PRODUCT CHANGE NOTIFICATION

PCN-SSR-231214

Temporary change on Thermal Pad for hockey puck SSRs

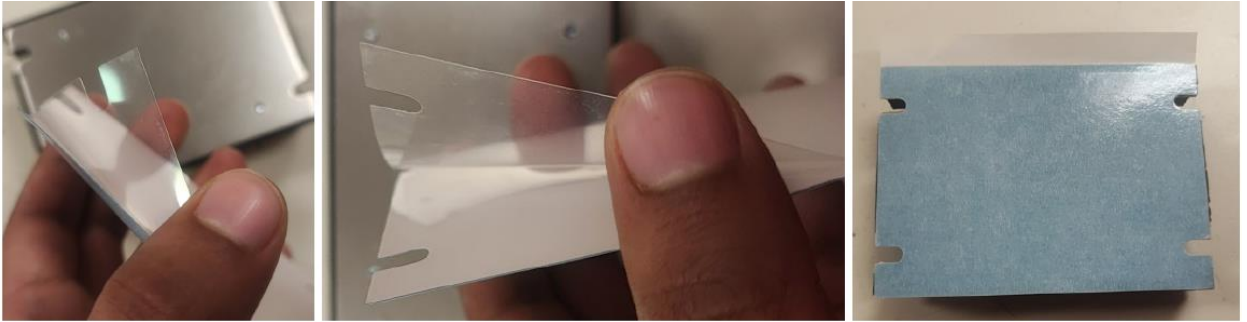
The original material used on this thermal pad is **TCF1000AL**, while the new proposed material is **JRFT-FC200**.

- a. There is a color difference between these 2 materials. The original thermal pad has a gray color while the thermal pad made with the new proposed material is pink, as shown in the images below.

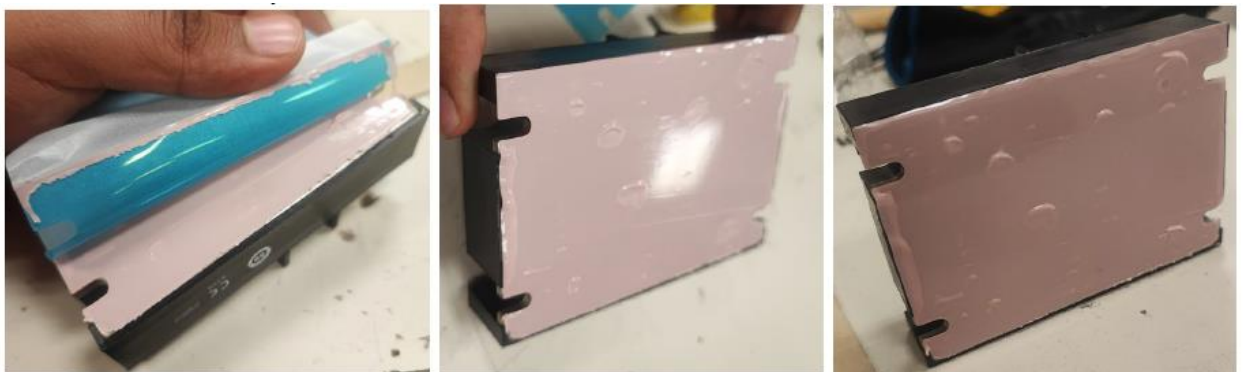
Here you can see the recommended steps to properly install this new thermal pad:

1. Have a clean surface on both the SSR backplate and the heat sink.

2. Remove the clear protective film of the thermal pad and line it up with the SSR.

3. Scrap the surface of the thermal pad with a soft tool to get out bubbles trapped inside the surface and improve adherence. Let it sit for 5 minutes before peeling off the other protective film.
